**Southern California Edison (SCE) appreciates the opportunity to comment on the IPE Draft BPM Language Topic 15 – Material Modification Review. SCE has inserted its proposed edits and comments (in red font) directly below in the draft BPM language document posted by the CAISO on November 18, 2013.**

# Interconnection Process Enhancements

## Draft BPM Language Topic 15 - Material Modification Review

**November 18, 2013**

## Material Modification Review Process – High Level Overview

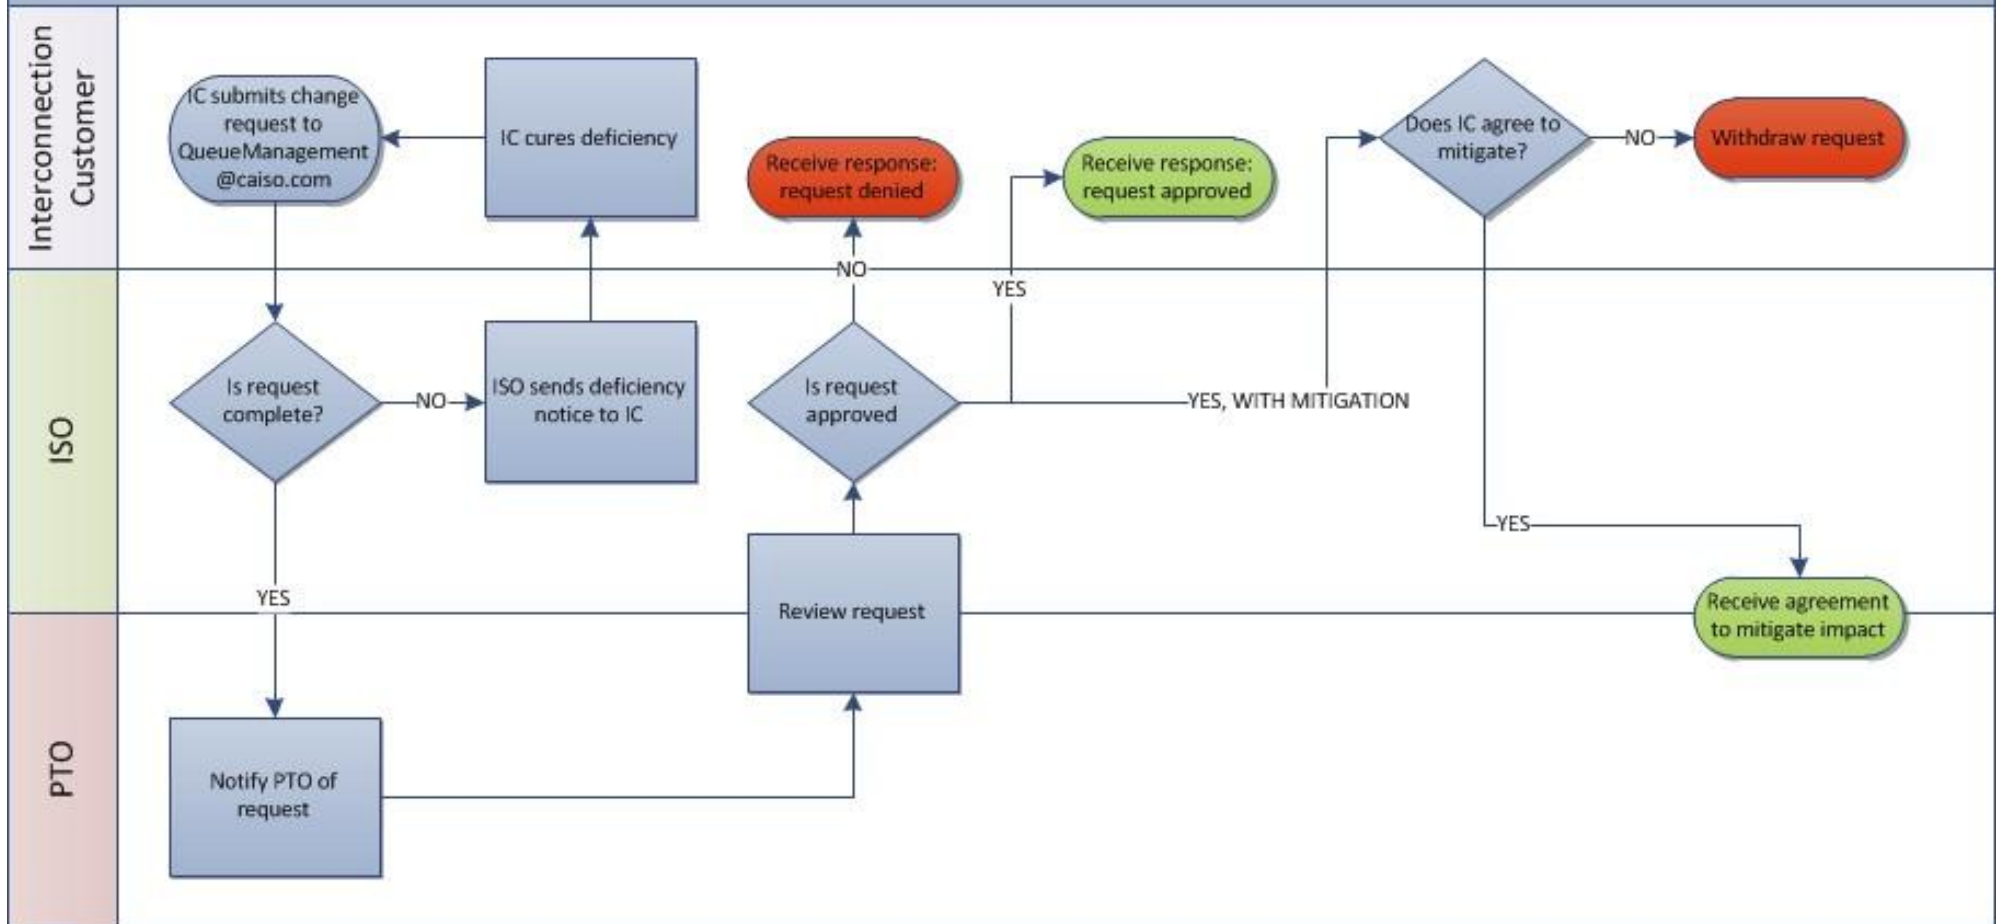
A graphical representation of the review process is presented on the next page. **(NOTE: One additional step is needed in the assessment process/diagram. The ISO should notify the IC and the PTO of the outcome of the Material Modification Review, as to whether the request is approved or denied. Currently, when SCE approves a Material Modification Review, SCE typically is not apprised the ISO regarding whether the request was finalized.)**
